**Amendment #1 -- Farrington Road**

**Durham-Chapel Hill-Carrboro Metropolitan  
Planning Organization**  
Comprehensive Transportation Plan  
Septembr 14, 2018

# Comprehensive Transportation Plan (CTP) DCHC MPO -- Amendment #1

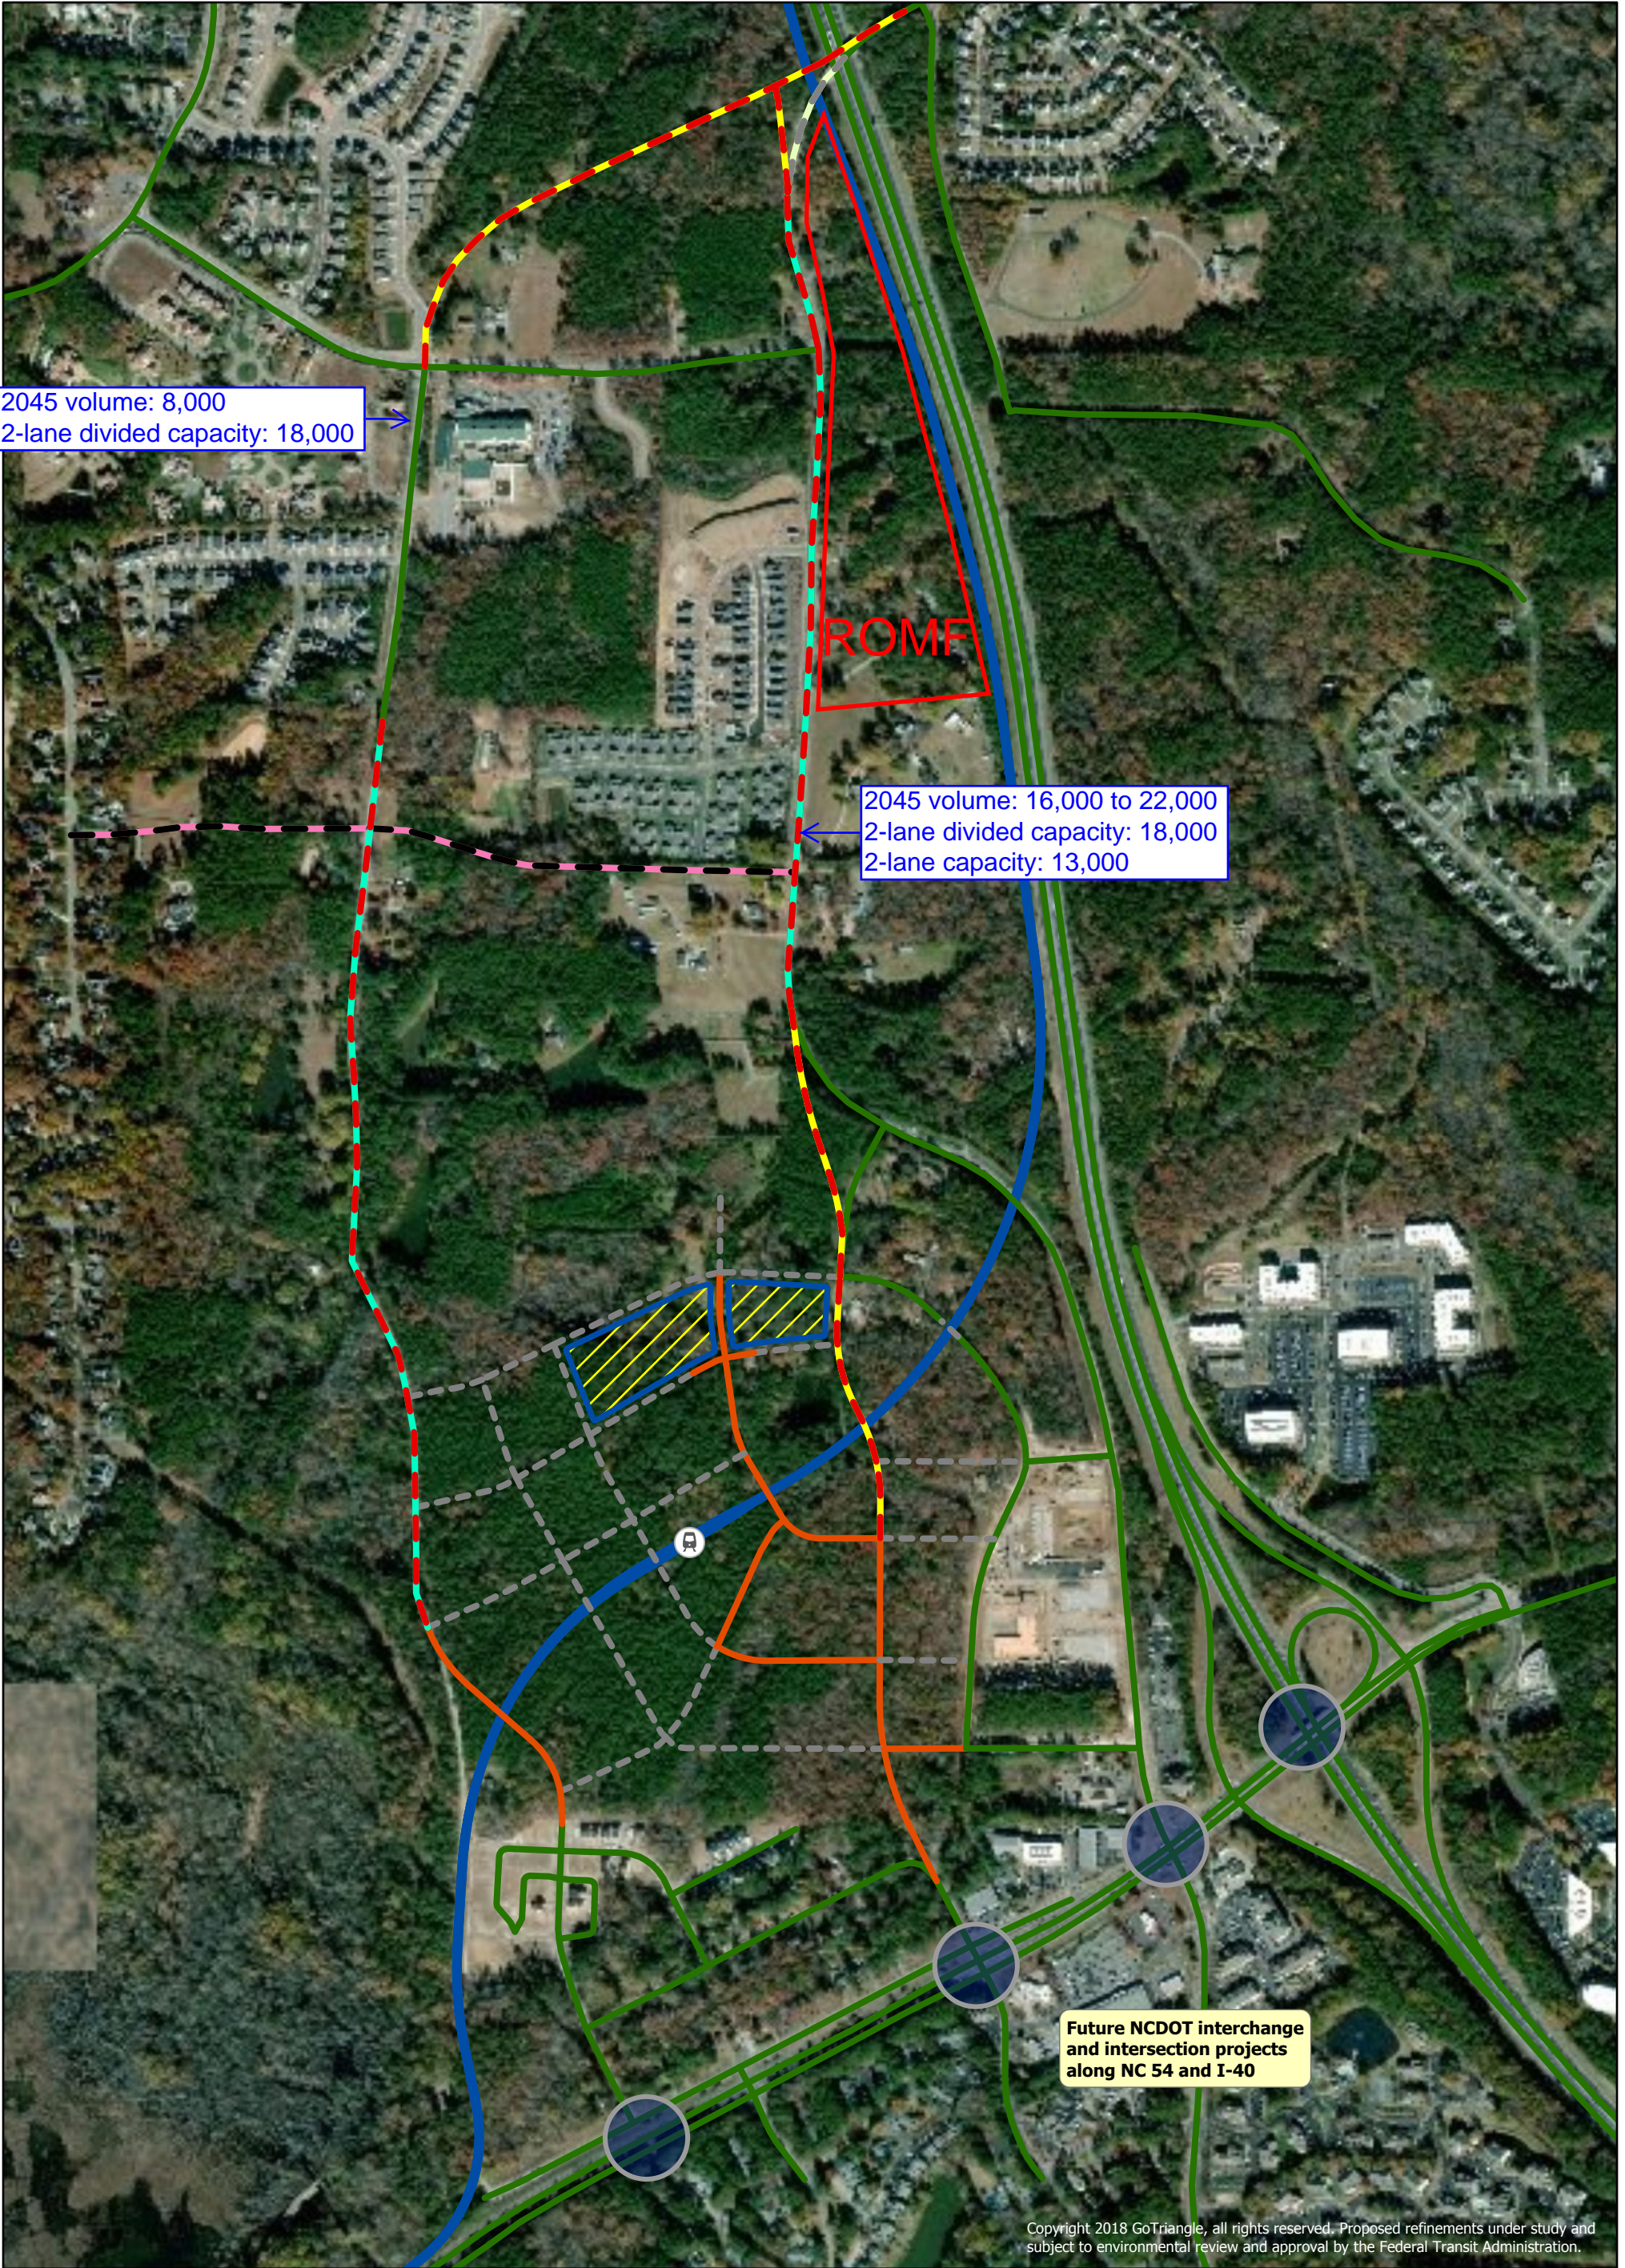
Amendment #1 changes this segment from 4-lane divided to 2-lane divided with bicycle and pedestrian facilities.
